# UNITED STATES PATENT AND TRADEMARK OFFICE

APPLICATION NO.	FILING DATE	FIRST NAMED INVENTOR	ATTORNEY DOCKET NO.	CONFIRMATION NO.
10/656,615	09/05/2003	Frank Sterns	20040-1-0220	8018

## Office Action Summary

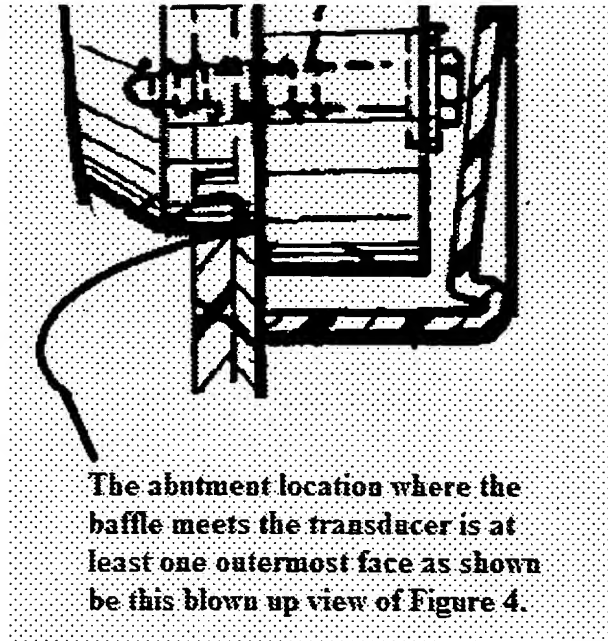
5. With respect to the Applicant's argument pertaining to claims 1, 6, and 9 that Reich fails to teach *a portion of the mounted transducer is secured between the flange and a portion of the baffle*. The Examiner disagrees.

Reich teaches that a portion of the mounted transducer is secured between the flange and a portion of the baffle (see illustration below). Furthermore, the term "secured" does not dictate a means by which the transducer must be secured, nor does the claimed language stipulate the fasteners can not be used. Thus, the rejection is maintained.

6. With respect to the Applicant's argument pertaining to claims 14, 19-21, 20-23 that Reich or the combination of Reich and Fulcher fails to teach *the outermost face of the transducer is not flush with the outermost face of the baffle*. The Examiner disagrees.

The transducer and baffle disclosed in Reich have multiple sides/outermost faces. And, Reich teaches at least one outermost face of the transducer substantially flush with an outermost face of the baffle (see illustration below).
